Re: City of Fort Collins East Rigden Pit Substitute Water Supply Plan (WDID 0302570, Plan ID 3055)

DRMS Permit No. M-1979-097 (WDID 0303021)

Approval Period: July 1, 2024 through June 30, 2025 Contact information for Mr. Daly: 970-416-4214; mdaly@fcgov.com

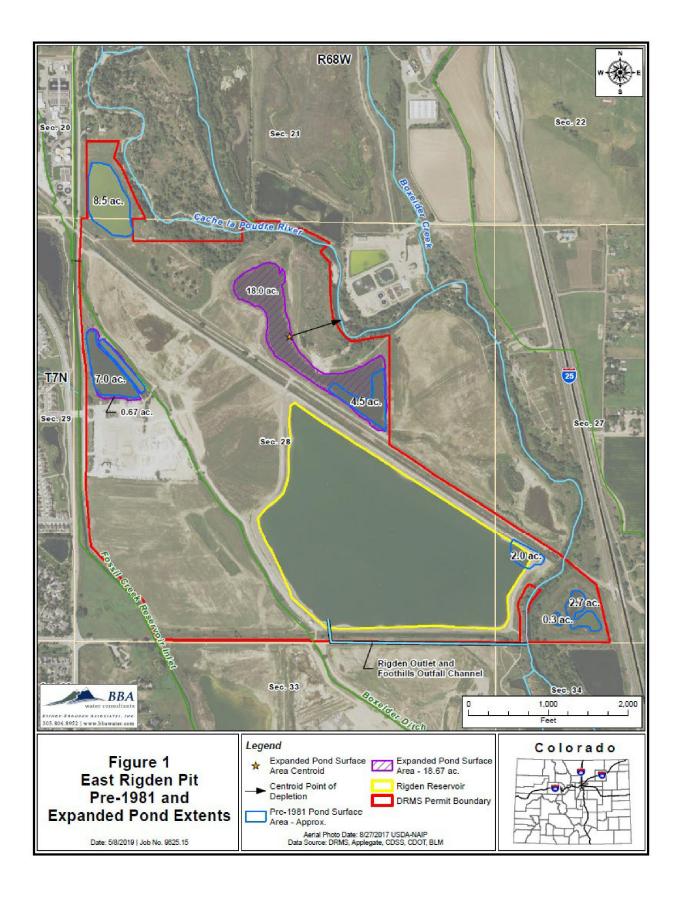
The East Rigden Pit is located south of the Cache la Poudre River in Sections 21, 27, and 28, Township 7 North, Range 68 West of the 6<sup>th</sup> P.M., as shown on the attached Figure 1. Past sand and gravel mining operations exposed groundwater at the East Rigden Pit, but the site has not been mined in many years.

Pursuant to section 37-90-137(11)(b), C.R.S., and case no. 2009CW49, a gravel pit operator or property owner does not need to replace depletions that occur due to evaporation from groundwater exposed prior to January 1, 1981 ("pre-81") as a result of open mining of sand and gravel, regardless of whether mining continued after December 31, 1980. The May 17, 2011 SWSP Approval documented the location of 25 acres of groundwater exposed at the East Ridgen Pit at that time which were recognized as having been exposed at the site prior to January 1, 1981. Per the *State Engineer's General Guidelines for Substitute Supply Plans for Sand and Gravel Pits* updated April 1, 2011, pre-81 areas are tied to the physical location at which the groundwater was exposed prior to January 1, 1981, and may not be re-allocated to other areas of groundwater exposure within the gravel pit boundary. The pre-81 areas of groundwater exposure as documented in the May 17, 2011 SWSP Approval are shown in blue on the attached Figure 1.

A compacted clay liner was constructed around the portion of the East Rigden Pit shown in yellow on the attached Figure 1 in September 2014. The liner was approved by the State Engineer's Office as meeting the design standard for liners on May 20, 2015, and classified as a lined reservoir in accordance with the August 1999 State Engineer Guidelines for Lining Criteria for Gravel Pits (Rigden Storage Reservoir, WDID 0303326). The February 27, 2015 SWSP Approval stated that upon approval of the compacted clay liner, no depletions associated with the East Rigden Pit would remain after the conclusion of that plan period and no subsequent SWSP was anticipated to be required for the site, due to all areas of groundwater exposure at that time either being within the lined area or within the 25 acres documented as having been exposed to the atmosphere prior to January 1, 1981.
